DOCUMENT 00911

ADDENDUM NUMBER 1

Issued: December 9, 2010

**1315 Airport Boulevard Tenant Improvements
(Architectural Construction, Site Work, and Electrical)**

1315 AIRPORT BOULEVARD TENANT IMPROVEMENTS
INTERIOR ELEVATIONS (LABS, SCADA, LOCKER ROOM)
 FILE NAME: SCWA_1315Airport_Interior-Addendum.dwg CONTRACT NUMBER: 0-83-7 #02
 DRAWING NUMBER: A-17 SHEET 20 OF 50

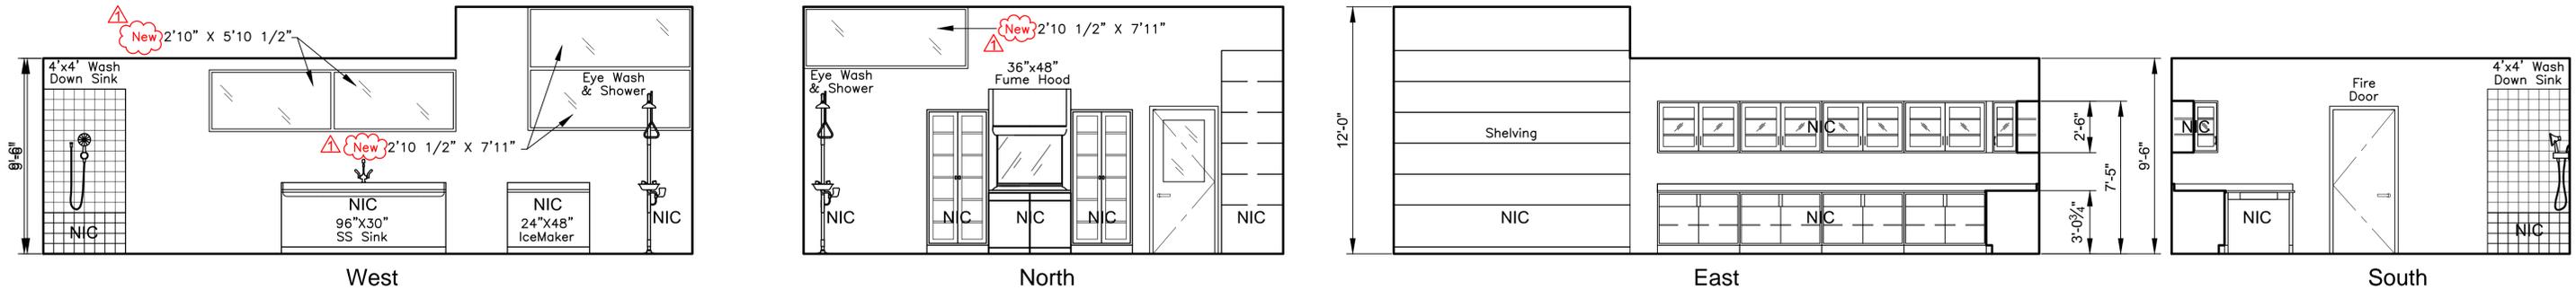
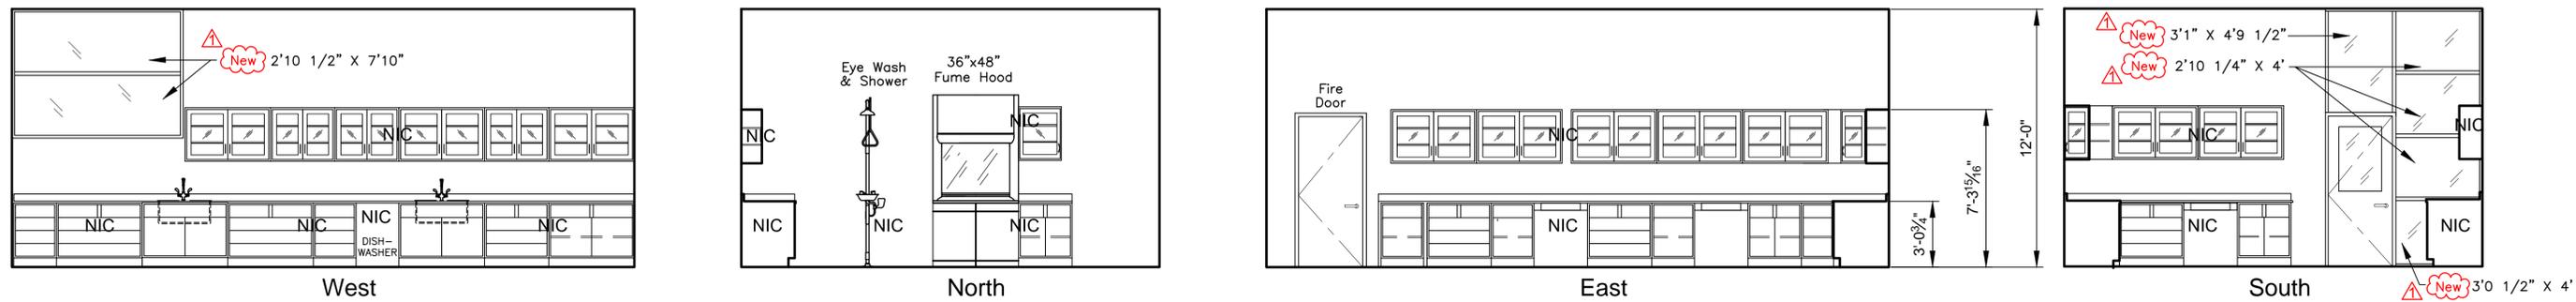
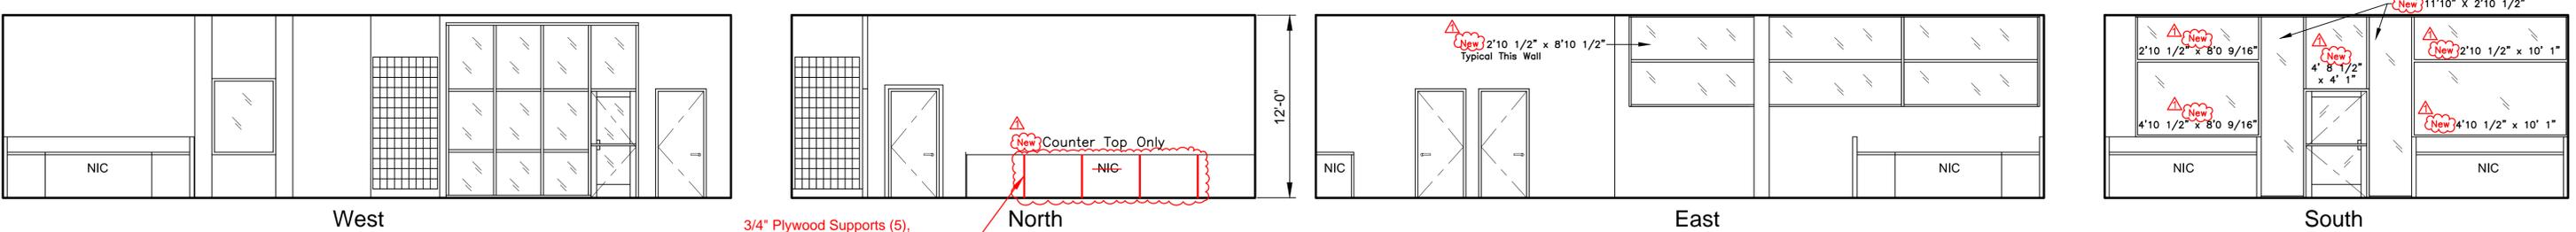
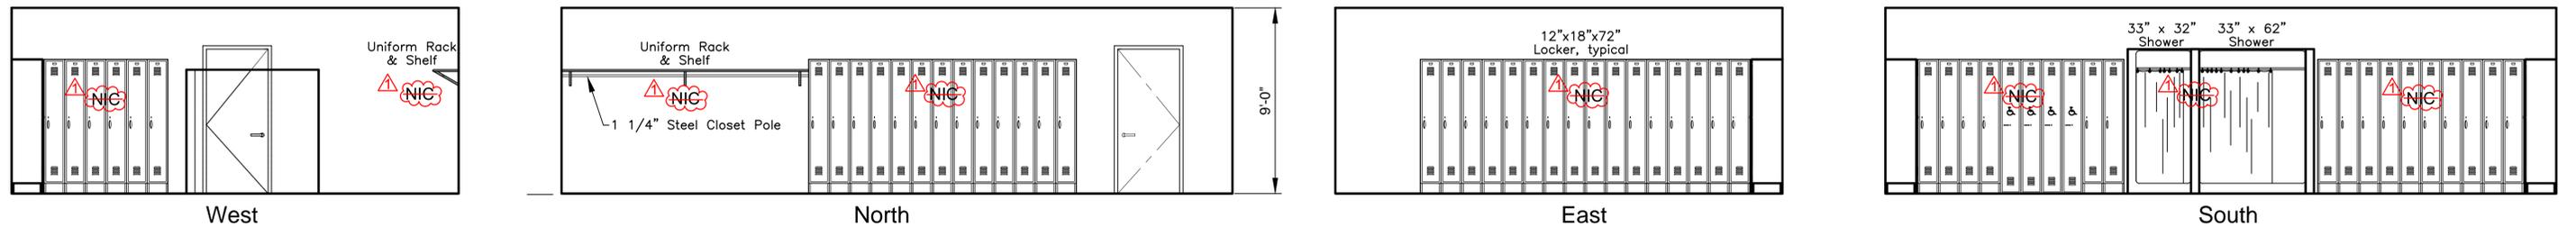
- G. Delete Drawing A-7 and replace with attached Drawing A-7, marked "12-8-2010 Addendum No. 1."
- H. Delete Drawing A-8 and replace with attached Drawing A-8, marked "12-8-2010 Addendum No. 1."

3. The lockers and benches are in the specifications and shown in the plan view, but in the elevations they are noted as NIC. Please confirm if they are to be included or not.

2. Sections 06200 and 06410 are included in the specifications. When looking at plans Cabinet Work and Counter Tops have a NIC indication. Are we to include or not include in our bid?
